Addendum No. 3
OSWWTP Phase 1 Replacement Project
Corolla, Currituck County, North Carolina
June 22, 2015

FABRICATED PIPE THIMBLE
(ALL PIPE PENETRATIONS THROUGH CONCRETE WALLS)

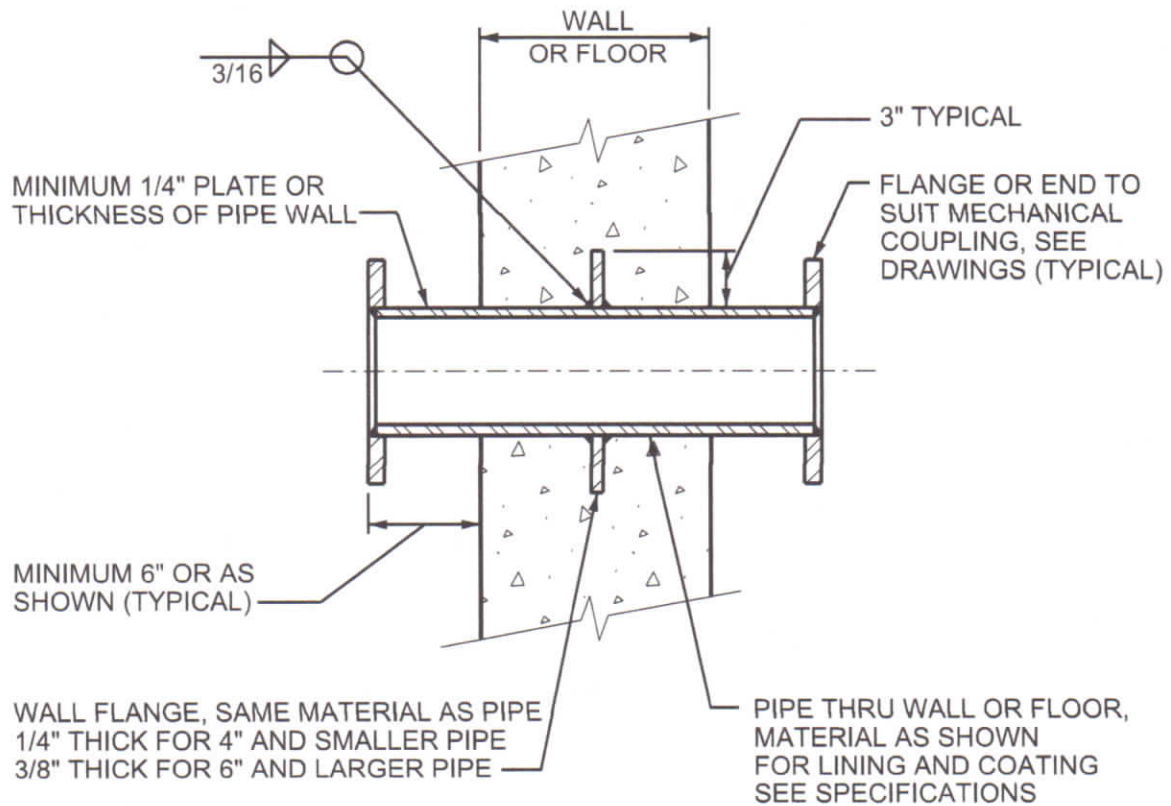
1. Please see the attached additional detail entitle “Pipe Penetrations Through Concrete Walls, AS-2” regarding pipe penetrations through the concrete body of the plant and headworks facility. All pipe penetrations below the normal or maximum working liquid volume within the plant will be installed according to this detail with a “water-stop” style thimble piece. Please note that all PVC pipe connections to these thimble pieces will be by matching flanges. In the case of PVC connections this connection can be achieved by Van Stone Flange PVC fittings.
2. Please note that the chemical feed pump responsible for dosing liquid chlorine to the final treated effluent stream must be a model with acrylic parts that are suited to handle chlorine.

1. WHERE CALLED OUT ALL METALLIC PARTS SHALL BE TYPE 316 SS
2. WALL REINF NOT SHOWN FOR CLARITY- MAINTAIN A 1" MIN CLEAR DISTANCE BETWEEN PIPE THIMBLE AND WALL REINF
